Design Review Board Case #2018-0002
Eisenhower East - Block 6A/200 Stovall Street

Application	General Data	
Project Name: Eisenhower East – Block 6A/200 Stovall Street Location: 200 Stovall Street Applicant: Perseus Realty, LLC	DRB Date:	March 15, 2018
	Site Area:	1.5 acres (65,161 sf)
	Zone:	CDD#2
	Proposed Use:	Residential, Retail, and Associated Parking
	Gross Floor Area:	630,583 sf
Purpose of Application: The second, and final concept review of the architectural façade improvements and additional building levels associated with the adaptive reuse of an existing, vacant office building at 200 Stovall Street to residential and retail uses with associated parking. This proposal includes 36,475 sf of retail and 594,108 sf of residential uses.		
Staff Reviewers: Rob Kerns, AICP robert.kerns@alexandriava.gov Thomas H. Canfield, AIA tom.canfield@alexandriava.gov Nathan Imm, nathan.imm@alexandriava.gov Stephanie Free, PLA, LEED GA stephanie.free@alexandriava.gov		
DESIGN REVIEW BOARD ACTION, March 15th 2018: The Eisenhower East Design Review Board (DRB) unanimously <u>approved</u> the design of the façade improvements and the three additional floors of new construction as presented by

Figure 2: Existing and proposed façade treatments.

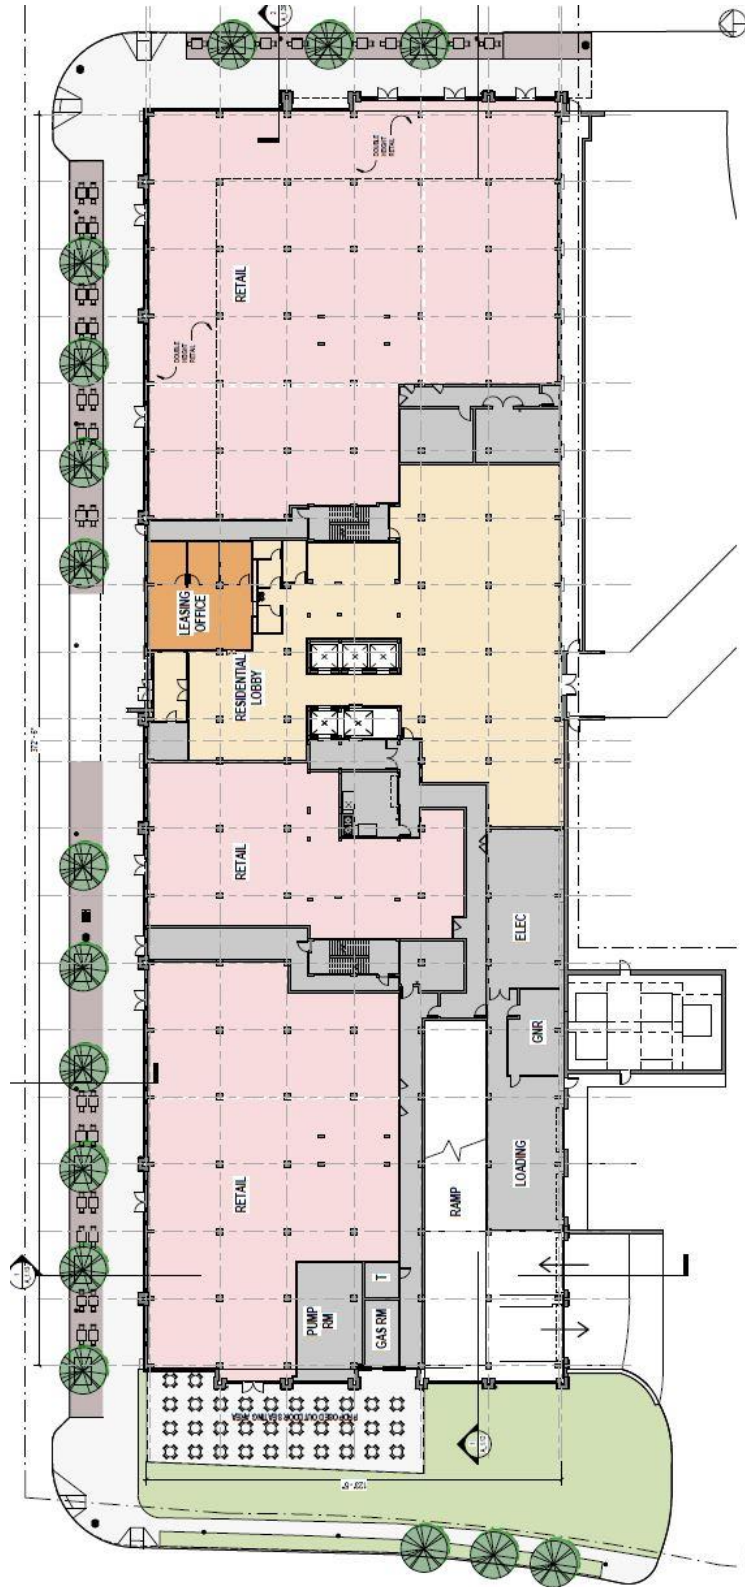
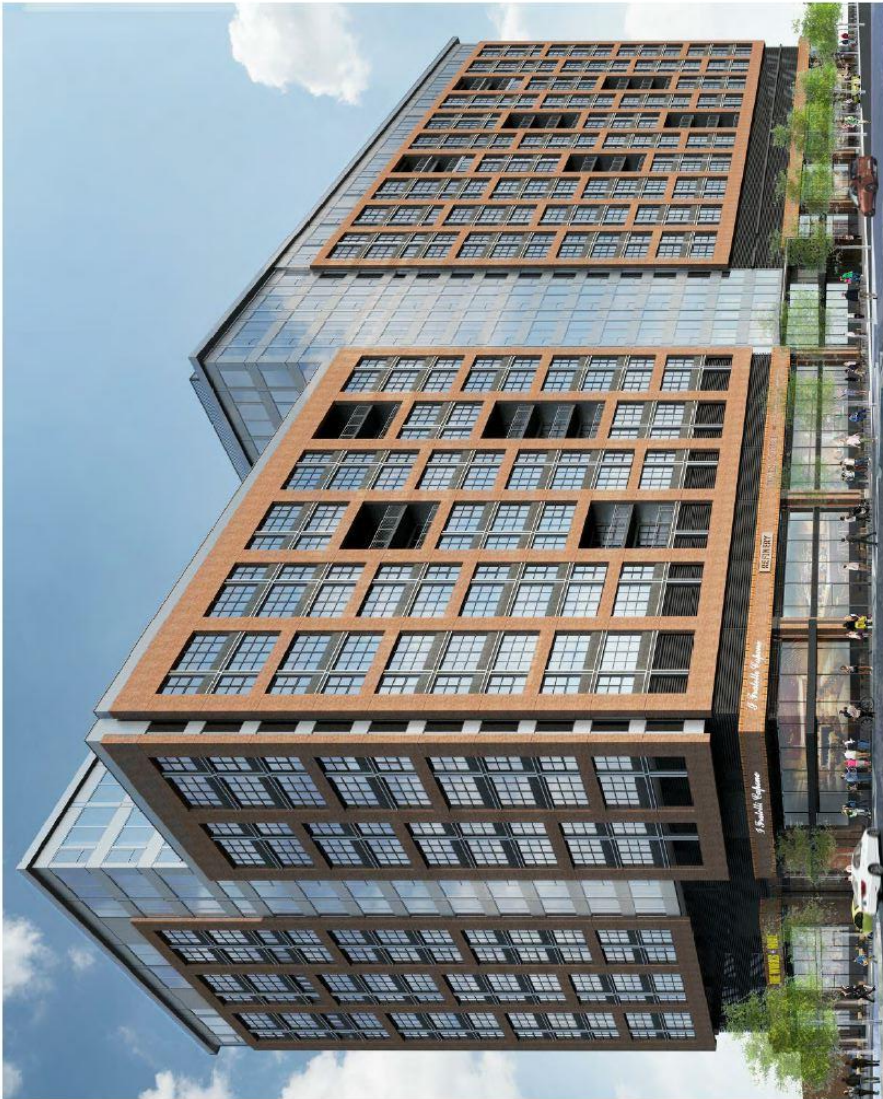
The greatest change to the building design from the former concept presented to the DRB in July 2017 is the revised materiality and color of the arcade at the lower levels of the building. The former, light-colored arcade successfully enhanced the appeal and legibility of the lobby and retail spaces, and also created a sense of continuity of the retail arcade in contrast to the dominant residential portion of the building's facades. For these reasons, Staff encourages the applicant to proceed with a light-colored brick for the arcade material, rather than the red brick blend which is currently proposed. Another distinct difference between the former and current arcade concepts is the expression of the building columns as they relate to the first floor retail. Here, the brick is set within a black, painted structural steel channel, framed with additional steel channels at the top and bottom of the columns as measured by the height of the first floor. Staff finds the intricacy of the column design to be a successful strategy to transition the building scale to the pedestrian realm, and encourages the applicant to apply a similar design detail, with steel channel and brick, to the overhead, horizontal portion of the arcade. The currently proposed top and bottom bands of soldier course brick that line the edges of this horizontal band read as very traditional in style and could more successfully relate to the contemporary design of the building if detailed similarly to the arcade columns.

- b. Arcade Color and Materials: Staff finds the combination of brick and painted structural steel materials to be successful. However, Staff encourages the applicant to use a lighter color brick on the arcade in lieu of the red blend brick used on the majority of the building in order to provide contrast and emphasize the retail and lobby entrances. Additionally, Staff recommends that the applicant eliminate the soldier courses along the top and bottom edges of the arcade's overhead, horizontal band and instead implement a lintel design detail similar to the structural steel and brick detailing of the column expression.
